ADDENDUM TO BID

PROJECT: RIVERCREST CDD
MULTI PURPOSE FIELD
MAINTENANCE BUILDING & DOG PARK
POOL & CABANNA

ADDENDUM DATE: MAY 15, 2014

ADDENDUM NUMBER: 05

1 POOL CABANA LEFT ELEVATION
3/8" = 1'-0"

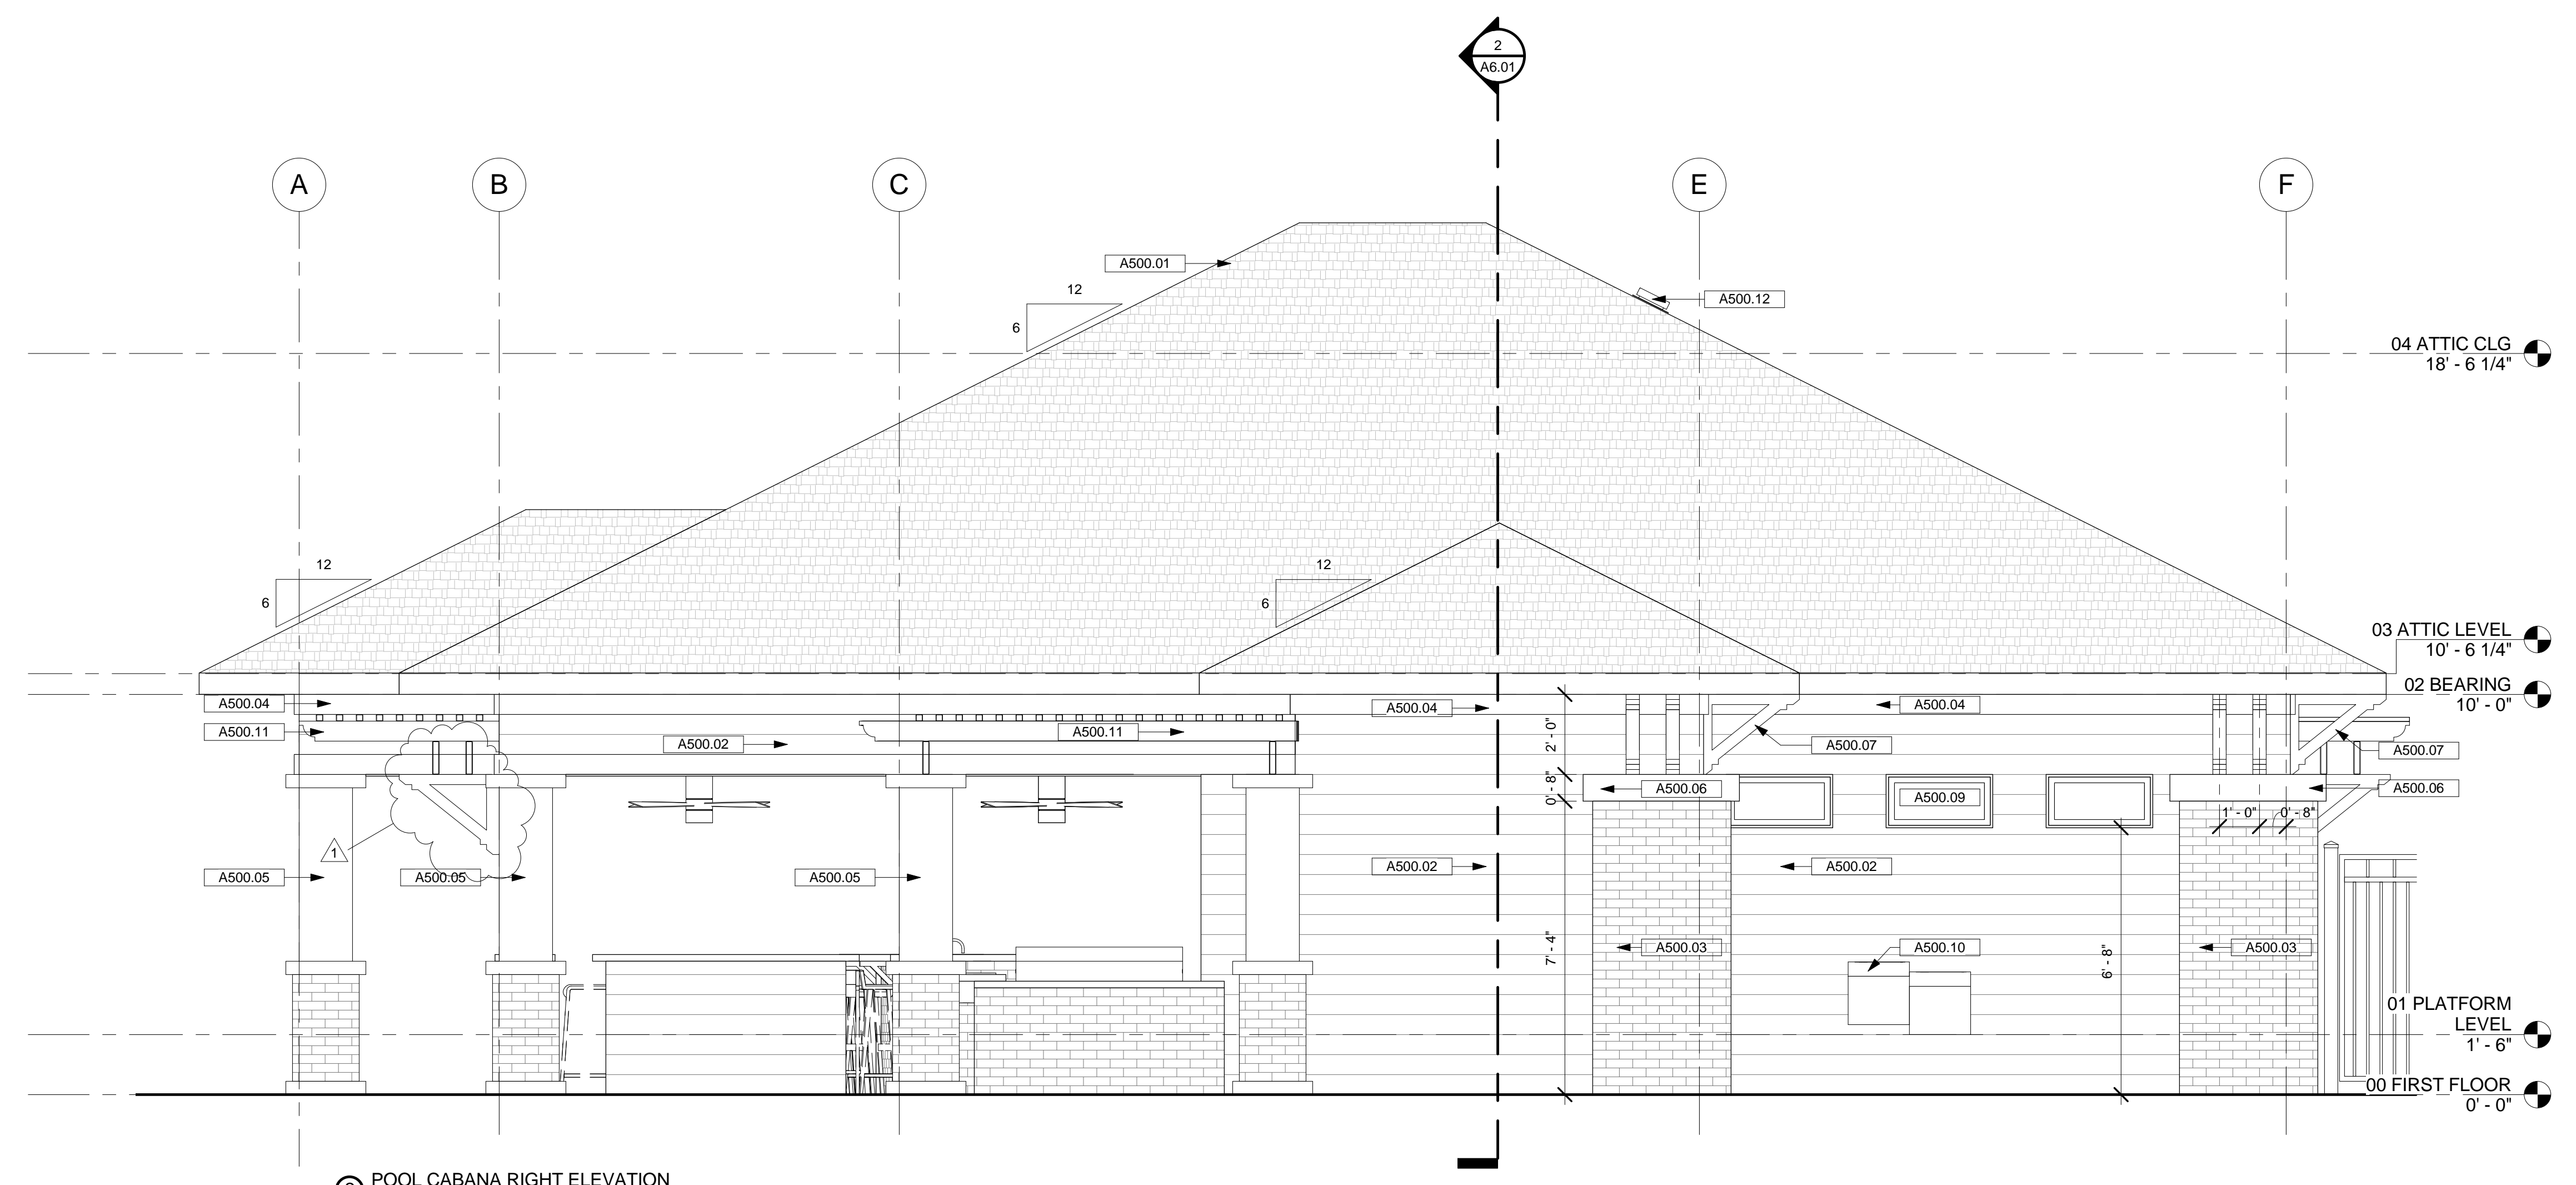
1. Question: How is the front pergola on cabana supported?
a. Answer: the support is the same as the pergola at the rear maintenance doors, see revised A5.01 & 5.02
2. Question: A7.01 is not legible can you reissue
a. Answer: yes, See A7.01 reissued for clarity. No revisions made
3. Question: how do the shade devices work on the large arched pergola with non-parallel rafters?
a. Answer: Backyard America has confirmed that the rails for the shade device will run parallel by use of a continuous PVC wedge shaped horizontal support.
4. Question: Stabil Paver pattern "B" 8"x8" cannot be manufactured on a 2-3/8" thick paver. What can be done?
a. Answer: Paver Pattern "B" 8"x8" can be substituted by using a (2) 4"x8" on a "basket weave" pattern. Color and thickness DO NOT change.
